Access Compliance Report

Public Rights-of-Way

(Curb Ramps)

Intersection ID: 19699	Main Street: CHERRYCREST_LN	Cross Street: ROCKY_RIDGE_DR	Location: NW
ADA ID: 00AC28C6B62B	Ramp Type: PerpDiag	Initial Pass/Fail: Fail	Overall Compliance: No
Severity Score: 13.75			
Codes/Mitigation Info/Possible Solution		Field Measurements/Component Compliance

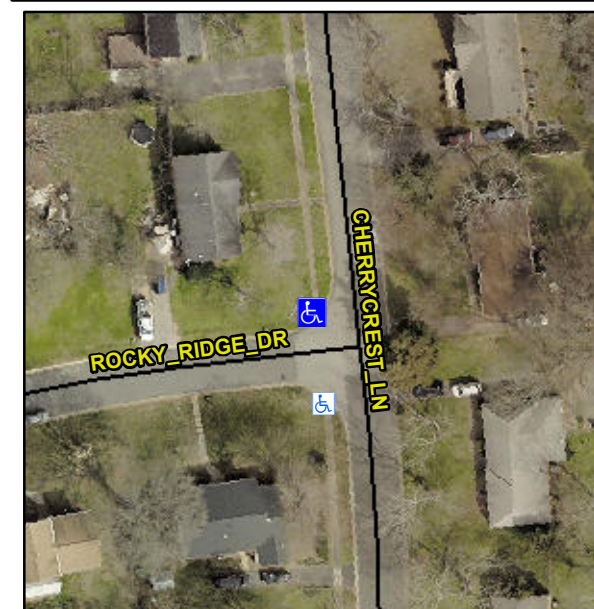
Not Found, R304.2.2, R304.5.3

Compliance	Description	Data	Compliance	Description	Data
N/A	Ramp Length (in)	48.0	No	Ramp Slope (%)	8.5
Yes	Ramp Width (in)	48.0	No	Ramp XSlope (%)	3.3
N/A	Flare Type LT	N/A	N/A	Flare Type RT	N/A
N/A	Flare Slope LT (%)	N/A	N/A	Flare Slope RT (%)	N/A
N/A	Flare Traversable LT?	N/A	N/A	Flare Traversable RT?	N/A
N/A	Landing Length (in)	N/A	N/A	DWS Provided?	N/A
N/A	Landing Width (in)	N/A	N/A	DWS Contrast?	N/A
N/A	Landing Slope (%)	N/A	N/A	DWS Length (in)	N/A
N/A	Landing X Slope (%)	N/A	N/A	DWS Full Width?	N/A
N/A	Landing Curb? (Y/N)	N/A	N/A	DWS Offset (in)	N/A
N/A	Shared Landing?	N/A			
N/A	Gutter Ponding?	N/A	N/A	Gutter Slope (%)	N/A
N/A	Gutter Lip Ht (in)	N/A	N/A	Gutter X Slope (%)	N/A
N/A	Painted X Walk1?	No	N/A	Painted X Walk2?	No
	X Walk 1 Direction	To S		X Walk 2 Direction	To E
N/A	X Walk 1 Width (in)	N/A	N/A	X Walk 2 Width (in)	N/A
	X Walk 1 Slope (%)	2.8		X Walk 2 Slope (%)	5.9
	X Walk 1 X Slope (%)	5.7		X Walk 2 X Slope (%)	0.1

Remove & Replace Curb Ramp With Two New Directional Ramps or Equivalent.
